Re: Westside Subway Extension

Re: Westside Subway Extension
Subj: Beverly Hills High School Master Plan Implications for Metro

Beverly Hills High School Plan Implications for Metro

Figure 8 – Typical Tunnel Cross Section and Zone of Influence

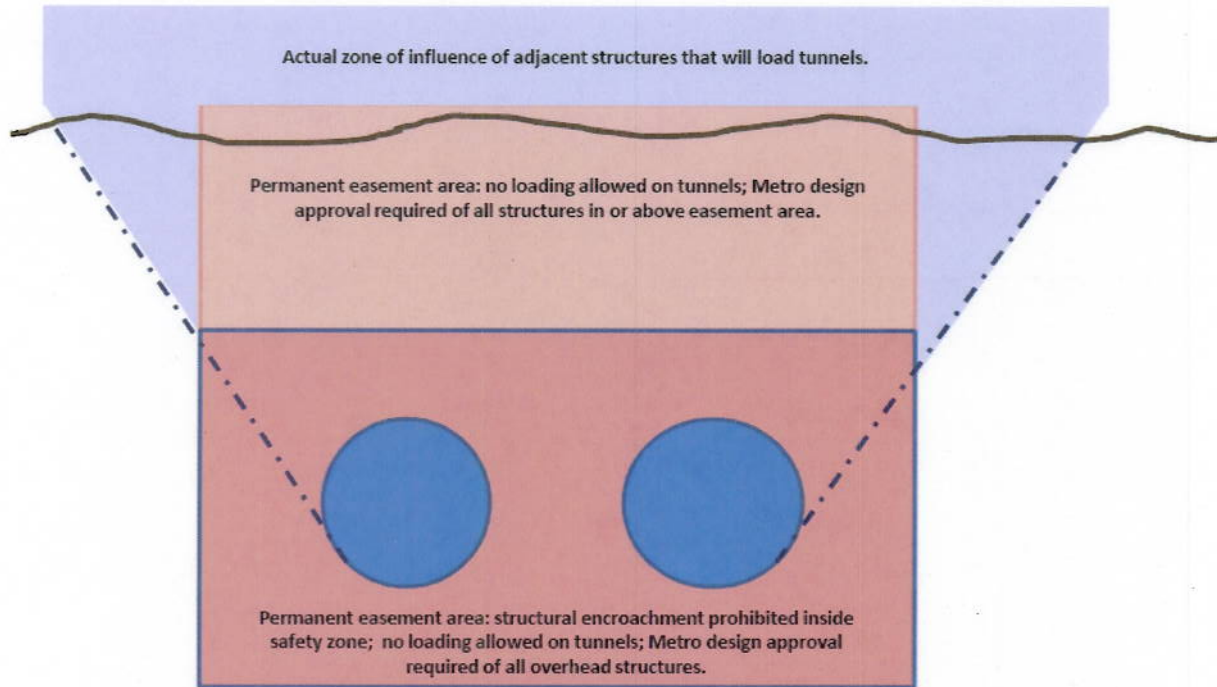
The typical Metro permanent underground easement contains a set of restrictions that would limit future campus construction:

- In the long term, Beverly Hills Unified School District will definitely build a new education building(s) and parking garage(s) in the area immediately above the Metro tunnels and covering the western two-thirds of the Beverly Hills High School campus prime building area. At best for Metro, this structure will have a lower floor elevation of approximately 235. This will create a vertical separation between the bottom of the building and the tunnel crown of less than 20 feet as shown on Drawing C-702H of the EIS/EIR, violating Metro's minimum separation standards for tunnel safety, settlement, and vibration. However, if the campus building site is constrained in any way (e.g. cannot remove Heath or utilities, need to avoid faults with new construction, environmental restrictions, or faults impacting existing buildings), or if the initial parking is simply continued across the site, this structure could easily have a bottom floor elevation (not foundation elevation) of approximately 185 - 200. This elevation will eliminate any vertical separation between building and the tunnels: the Metro tunnels would encroach inside the building for the entire length of the planned building by as much as 45 feet as shown on Drawing C-702H of the EIS/EIR.

- Beverly Hills Unified School District will definitely have existing 1930's era buildings that will remain in operation adjacent to or over the tunnel alignment for many decades. The Metro EIS/EIR states that there will be a minimum vertical separation of 50 feet between the existing building foundations and the tunnels. However, that is not correct for Buildings A, B and H and potentially Buildings E and F as well depending on the final alignment curvature selected by Metro. Based on Drawing C-702H of the EIS/EIR, Building E will have a vertical separation of 35 feet, Building F will have a vertical separation less than 20 feet, Building B will have a vertical separation of 45 feet to the first floor, and Building A will have a vertical separation of 40 feet to the first floor: the actual separation between existing building foundations and tunneling operations will be considerably less. This separation is well within the minimum separation used by Metro to prevent and mitigate any subsidence effects at the surface or under foundations and will provide an inadequate factor of safety for subsidence in violation of Metro standards and good engineering practice. It also is less than the minimum separation used by Metro to prevent vibration or vibration induced noise impacts on sensitive structures and will provide an inadequate factor of safety for vibration in violation of Metro standards and good engineering practice.
